**SUBJECT: Comment Response Letter (SF-19-014)  
Bent Grass Residential Filing No. 2 Sixth Submittal**

# MASTER DEVELOPMENT DRAINAGE PLAN

# FINAL DRAINAGE REPORT

# BENT GRASS RESIDENTIAL FILING NO. 2

## PROPOSED LOTS, TRACTS AND EASEMENTS MAP

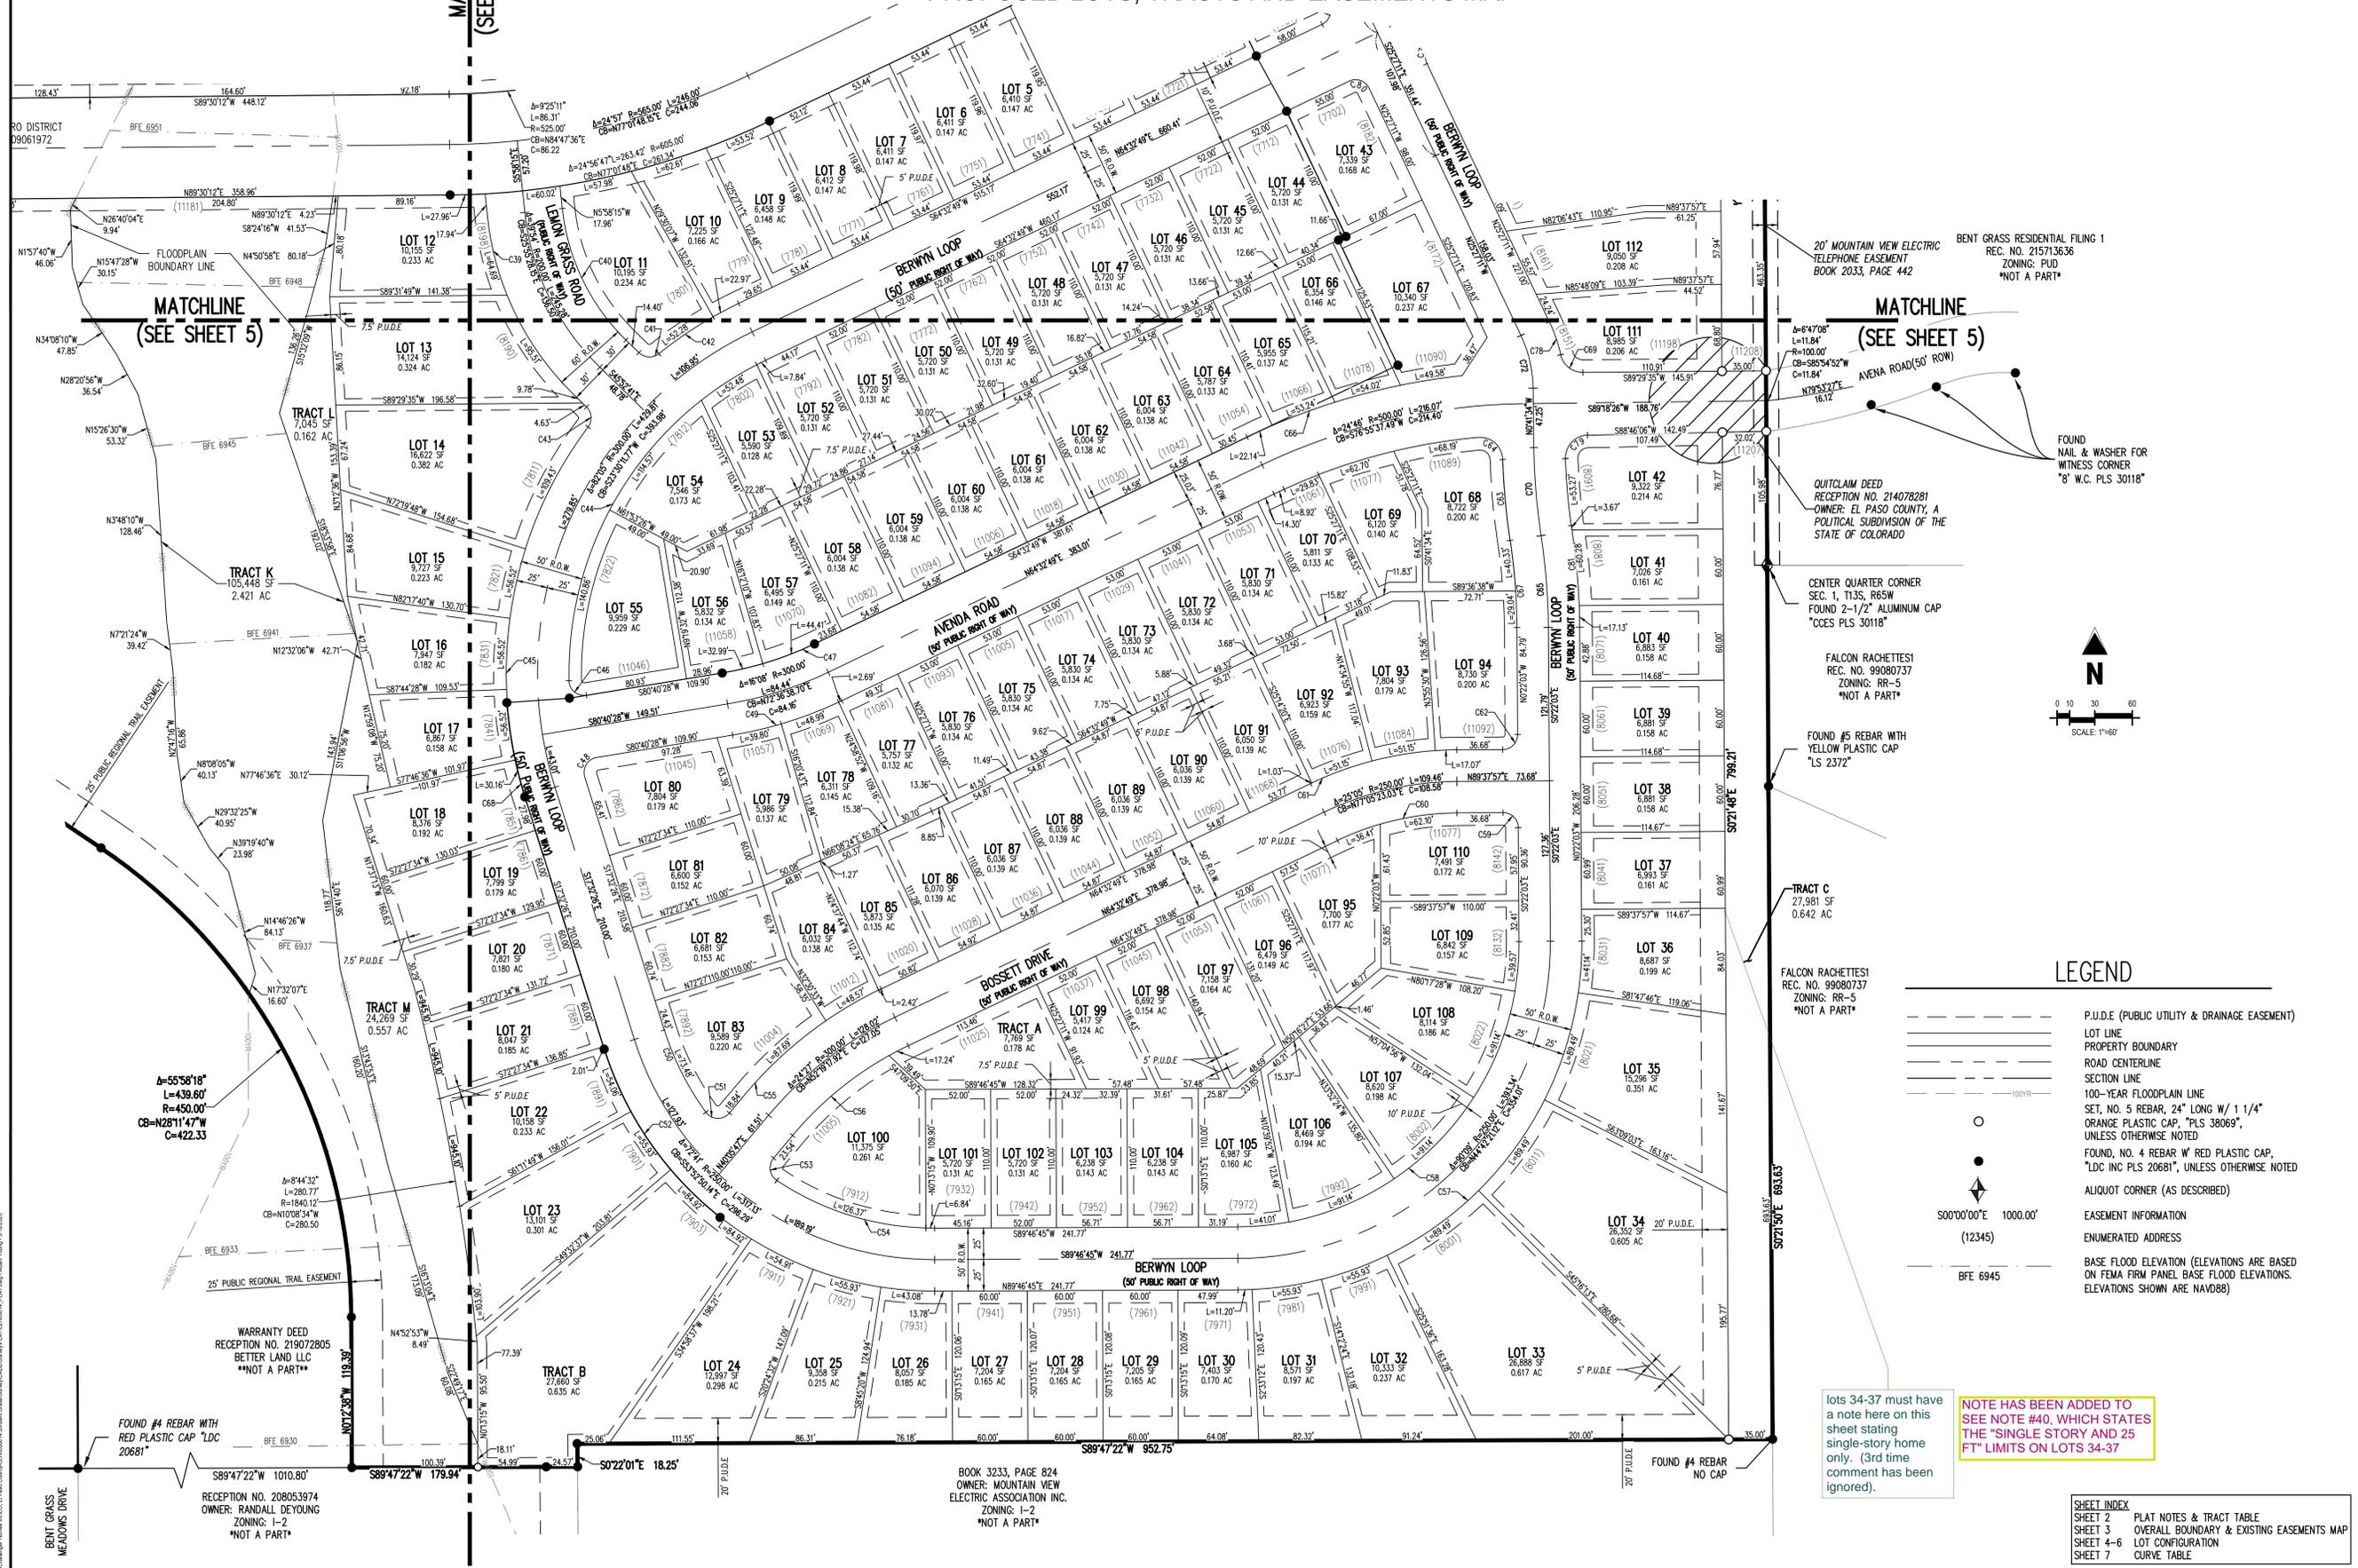
lots 34-37 must have a note here on this sheet stating single-story home only. (3rd time comment has been ignored).

**NOTE HAS BEEN ADDED TO SEE NOTE #40, WHICH STATES THE "SINGLE STORY AND 25 FT" LIMITS ON LOTS 34-37**
